Brooklyn Inland Wetlands Commission
Regular Meeting Agenda
Tuesday, November 14, 2023
Zoom and In-Person Meeting
Clifford B. Green Memorial Center
69 South Main Street
6:00 p.m.

**SITE PLAN MODIFICATION FOR
SPECIAL PERMIT # 22-007
FOR WEDDING/EVENT VENUE FOR
WILLOW HILL LLC
459 WOLF DEN ROAD
BROOKLYN, CONNECTICUT
DATED: SEPTEMBER 29, 2023
REVISED: NOVEMBER 8, 2023**

RE: Job #22172
Response to Engineer's Review
Special Permit for
459 Wolf Den Road
Brooklyn, CT

ENGINEERING PLAN AND DRAINAGE REPORT REVIEW PERTAINING TO PROPOSED WILLOW HILL EVENTS WEDDING/EVENT VENUE (ASSESSOR'S MAP 19, BLOCK 18 - LOTS 18A & 18B) WOLF DEN ROAD BROOKLYN, CT (November 1, 2023)

EVENT AREA PLAN
PREPARED FOR
WILLOW HILL LLC
459 WOLF DEN ROAD, BROOKLYN, CT
MAP 18 - LOTS 18 & 18A

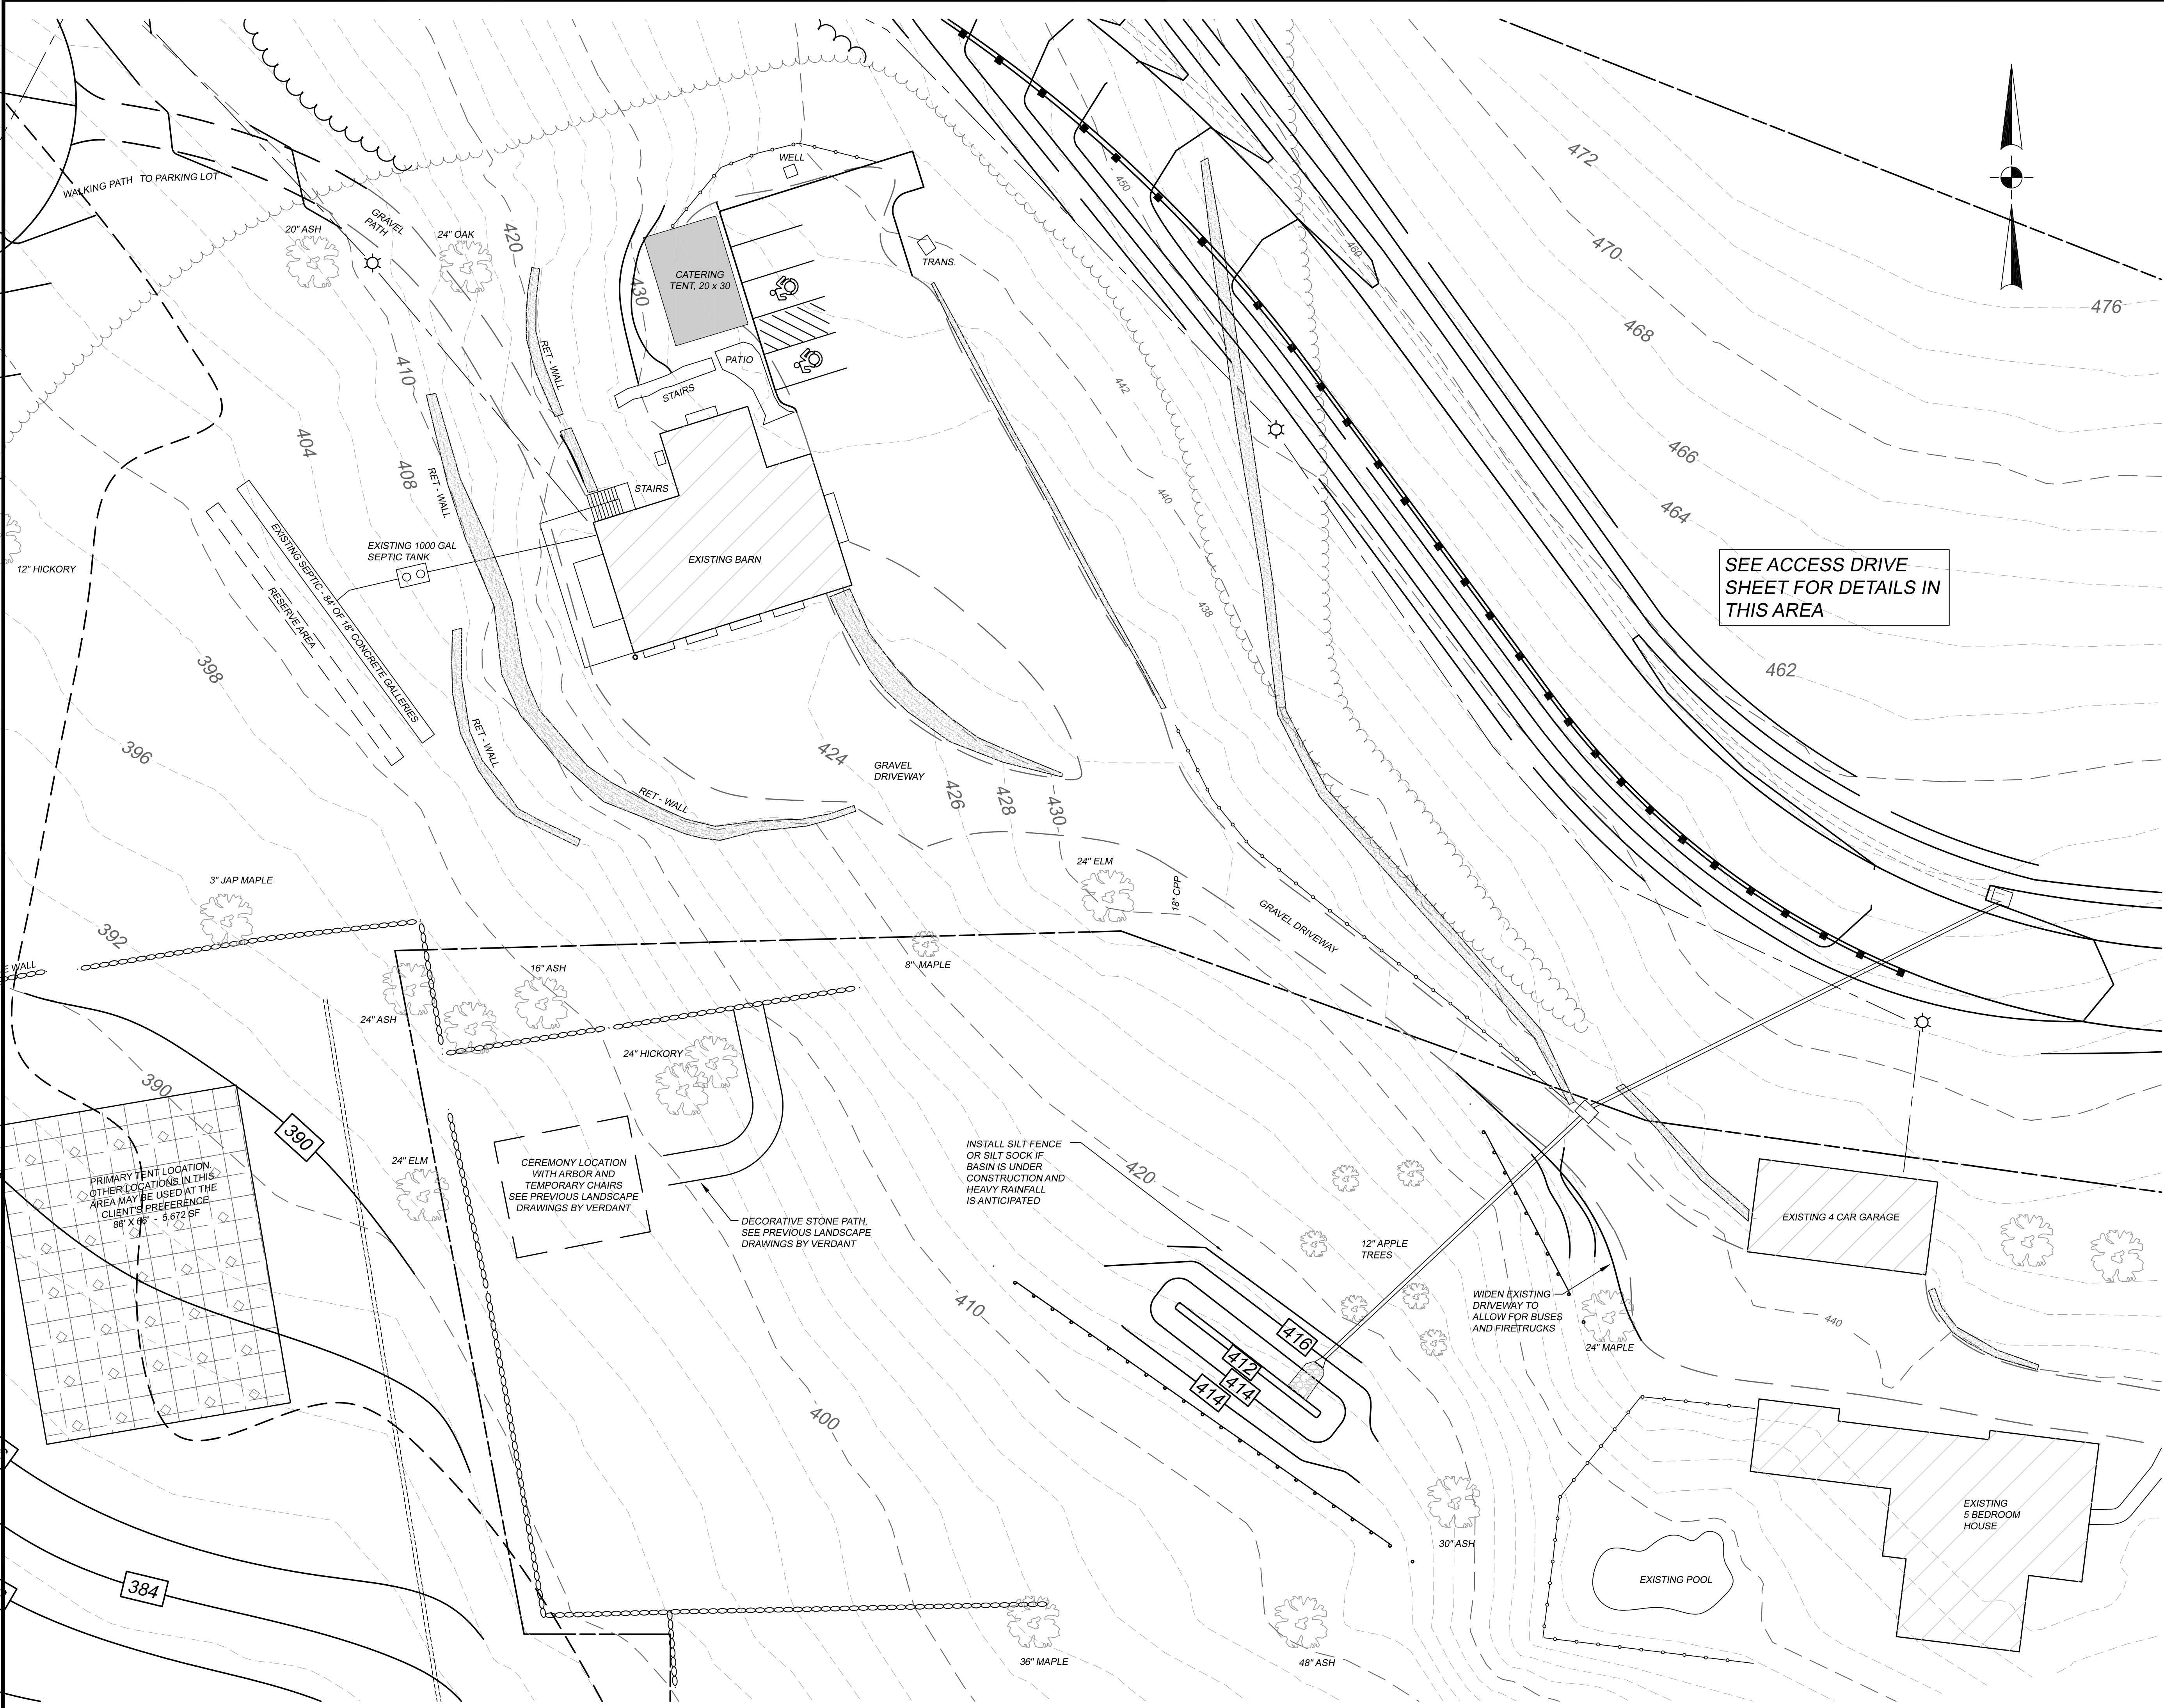
Event Area Plan – Sheet 3 of 5

1. A "north arrow" needs to be added to the plan.
2. All Verdant landscape plans need to be submitted for review to see if any impact on wetland on wetland areas. Verdant plans were not made available for this review.

Event Area Plan

1. A north arrow has been added.

2. Updated landscaping plans by Verdant have not been produced for this revision. The intent is to follow the previous landscaping plans exactly, with respect to the wedding location. Any landscaping in the proximity of the revised parking lot and access driveway will be substantially similar to the previously approved landscaping.
